NOTICE OF DECISION

DECISION OF THE PLANNING COMMISSION

**CLASS 3 DESIGN REVIEW / CLASS 3 SITE PLAN REVIEW / DRIVEWAY
APPROACH PERMIT CASE NO.: DR-SPR-DAP19-12**

SUMMARY: Proposed development of a new 324 dwelling unit multi-family apartment complex with associated parking, play and recreation areas, landscaping, and common building.

FLOOR PLAN
GARAGE 2 (15 GARAGES)

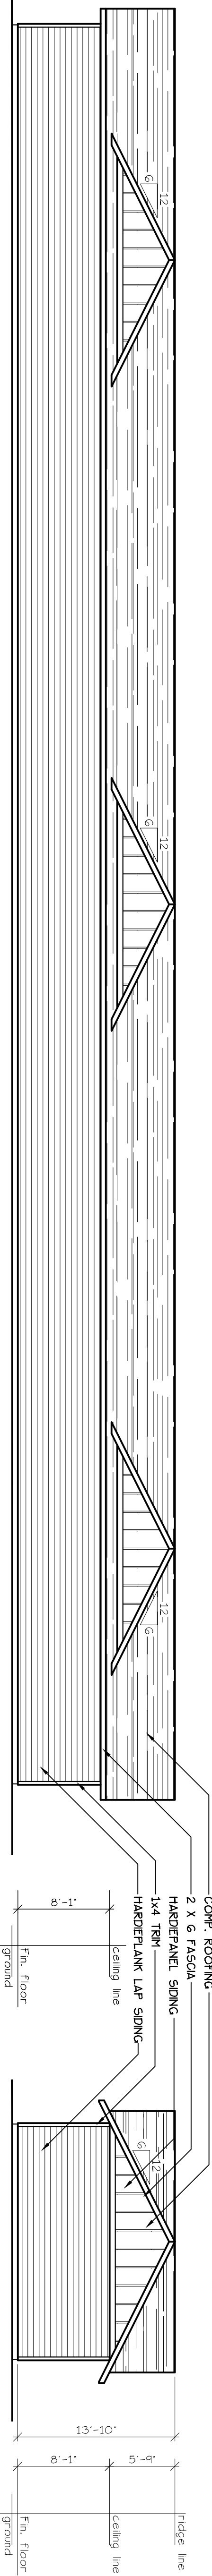
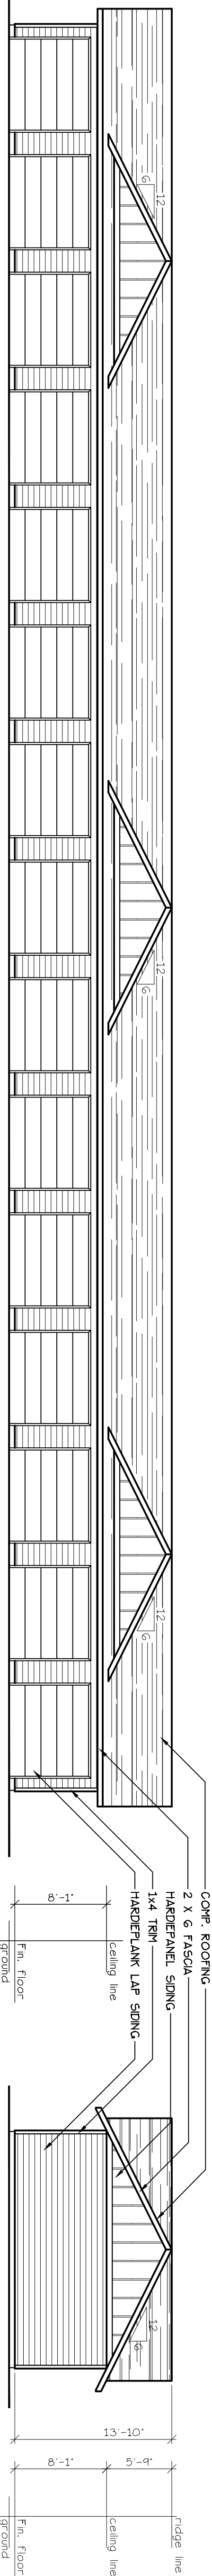
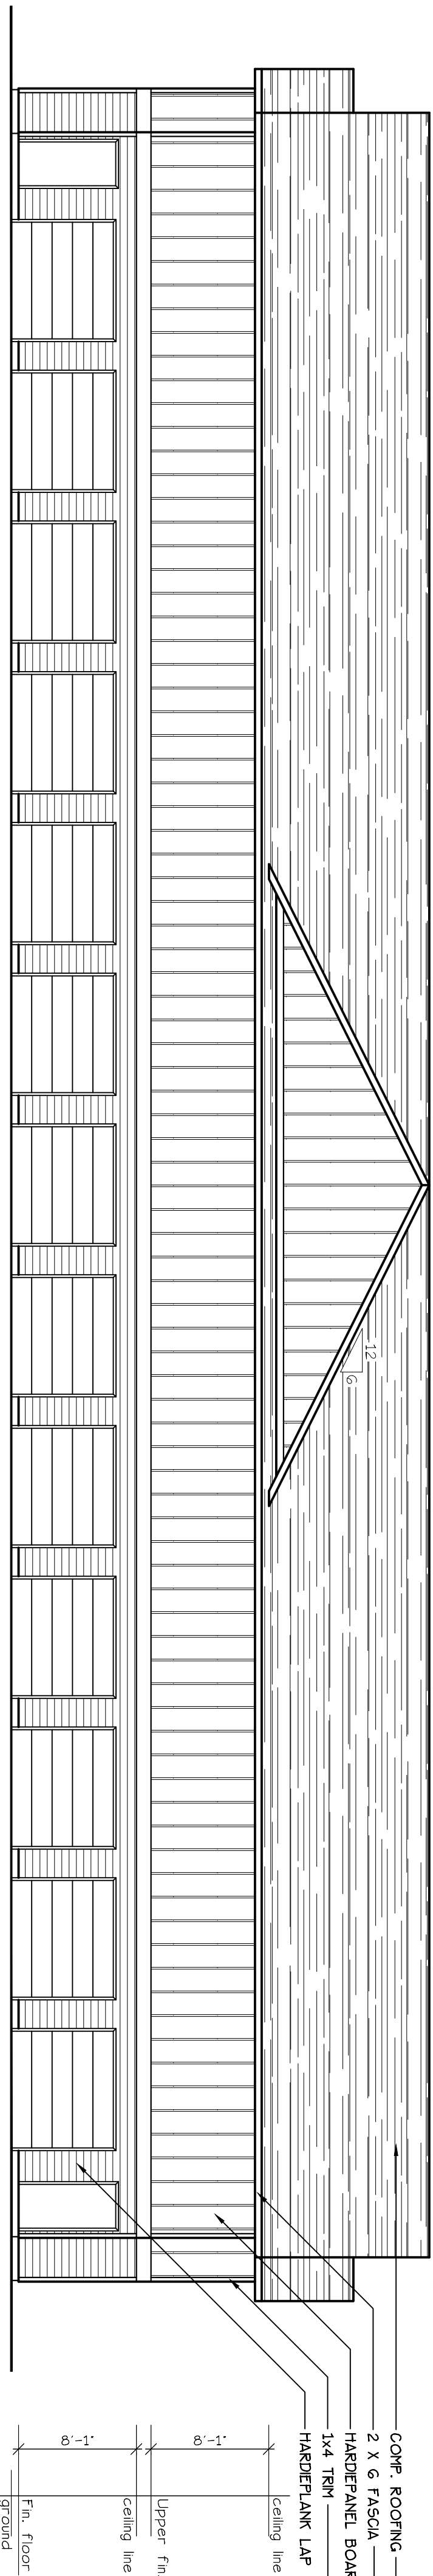
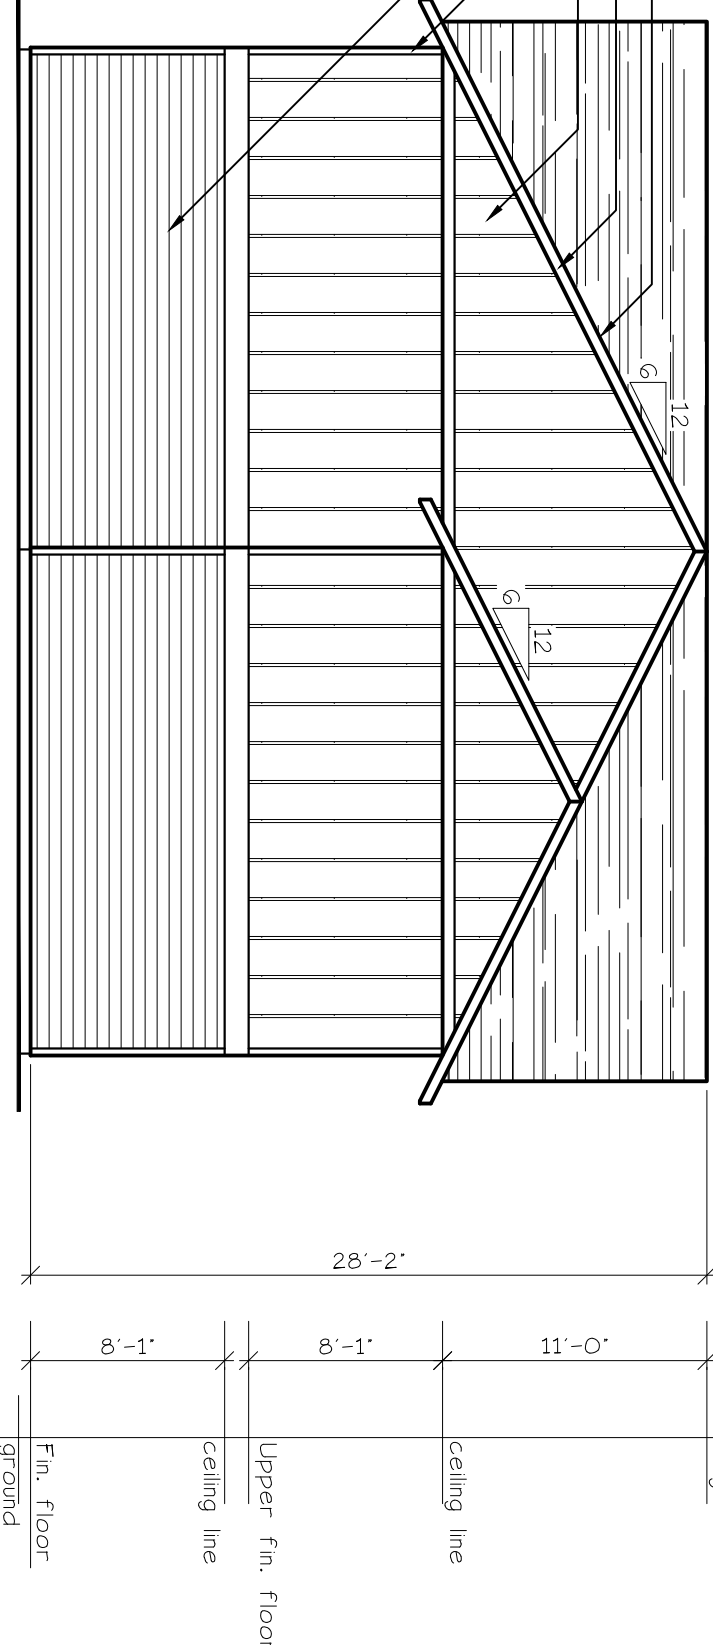
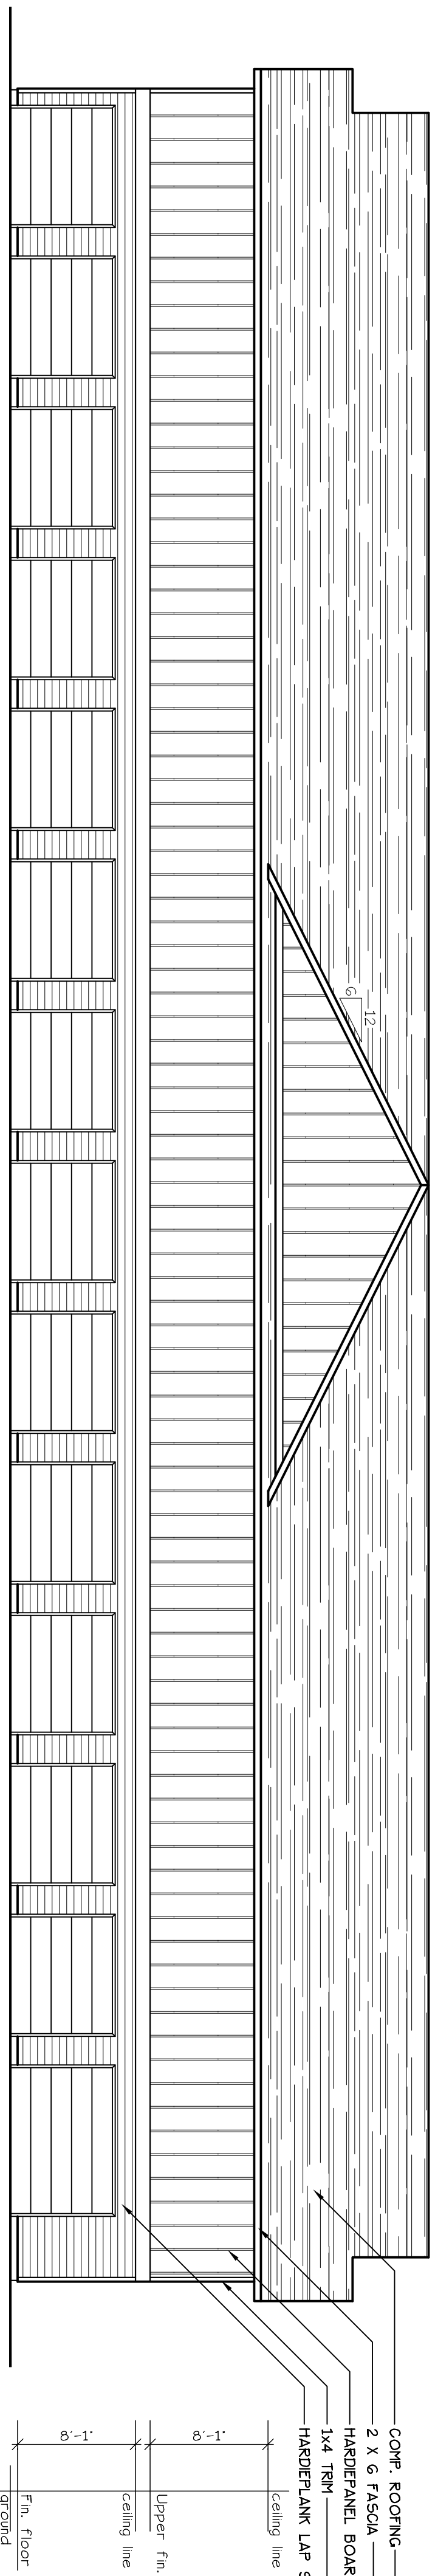
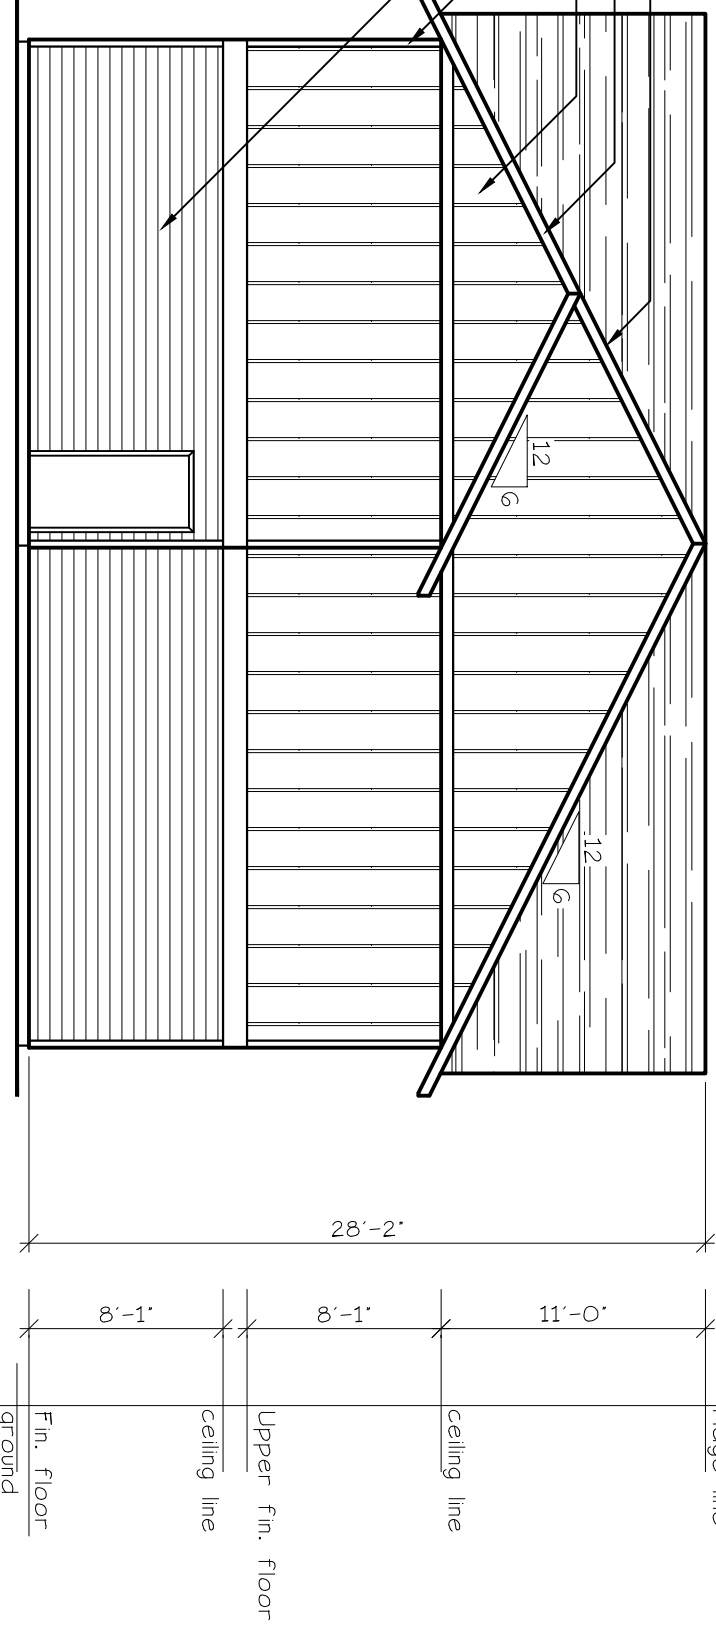
exterior wall. Three building exceeds the 150 feet in length standard. The proposed recreation building has articulation along the floor plan which breaks up the exterior walls meeting the guideline. The proposed Garage 2 and 3 exceed 150-feet in length and do not provide any articulation along the walls. The walls of the garages are long and monotonous, therefore to meet the guideline without altering the floor plan the following condition is recommended:

- Condition 4:** Garage 2 and 3 shall provide contrast and distinction by incorporating one or more of the following on at least 75 feet of the buildings:
- a) Vertically oriented lap siding, or horizontally oriented lap siding that is wider than that provided on the upper floor facades or is painted a different color than the upper floor facades; or
 - b) A siding material different from that used in the other portions of the building facades.
